STATE OF WASHINGTON DEPARTMENT OF ECOLOGY

Capital Industries Site# 11598755

Remedial Investigation Agreed Order #DE 5348

Revised Remedial Investigation Report

Attachment: Figure 1 – Total Chlorinated Ethenes Concentration in Groundwater

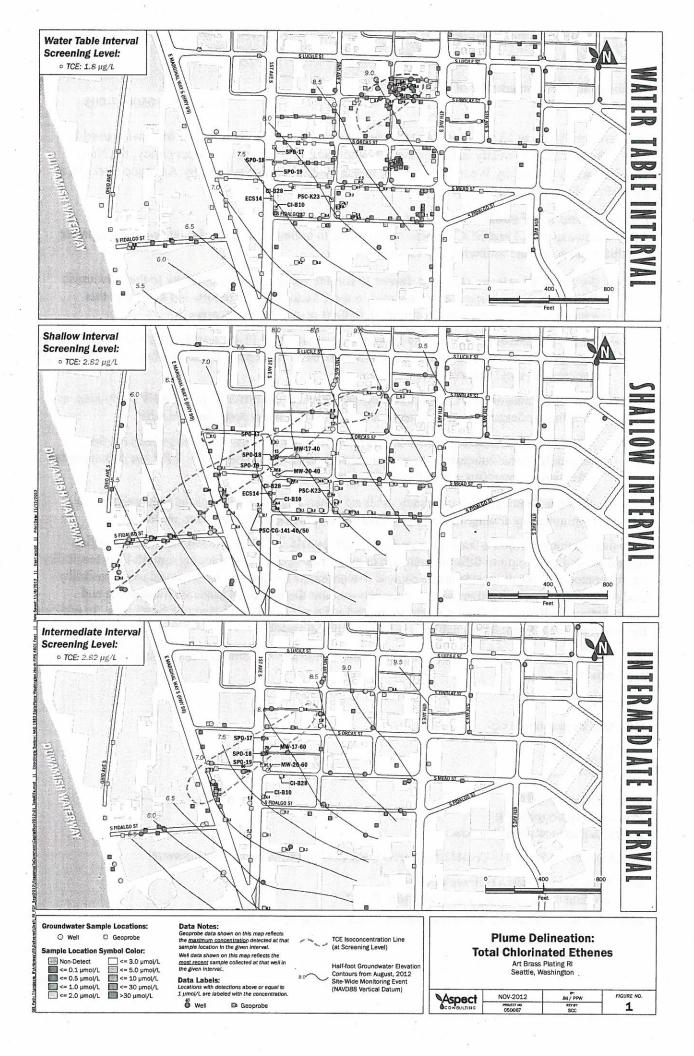
- Along 1st Avenue South, data indicate that the ABP plume centerline is located near ABP explorations SPO-18 and MW-17-40 and that concentrations decrease south of the centerline before increasing again in the CI study area. This pattern is clearly illustrated with the distribution of TCE and total chlorinated ethene concentrations in groundwater (refer to ABP RI Figures 15 and 19). We attached a modified version of Figure 19 showing total chlorinated ethene concentrations in groundwater (i.e., sum of chlorinated ethenes, expressed as molar concentrations) to illustrate this point. Groundwater data from ECS presented in the CI RI report have been added to the figure and it is annotated with select exploration IDs referred to in this letter. The transect defined by SPO-17, SPO-18, and SPO-19 confirms the ABP plume centerline, defined by the highest total chlorinated ethene concentrations, is close to the centerline delineated by TCE data. At the Shallow Interval,

- In Section 6.2.4.2, CI states that vinyl chloride detected in well CI-19-30 (adjacent to the Duwamish Waterway) represents the southern edge of the vinyl chloride plume from the ABP Facility. ABP does not agree. A review of the groundwater contour data for the Shallow Interval indicates that CI, BDC, and PSC are just as likely to contribute to the vinyl chloride detected at this well. The concentration at this well (1.7 μg/L in May 2012) is consistent with the diffuse area-wide vinyl chloride plume attributable to multiple sources. The vinyl chloride data contoured on Figure 24 of the CI RI report supports this assertion, showing a broad area with relatively low concentration (1.69 to 10 μg/L) of vinyl chloride extending well south of areas that could be conceivably impacted by releases at ABP, but clearly located downgradient of the CI and BDC facilities.
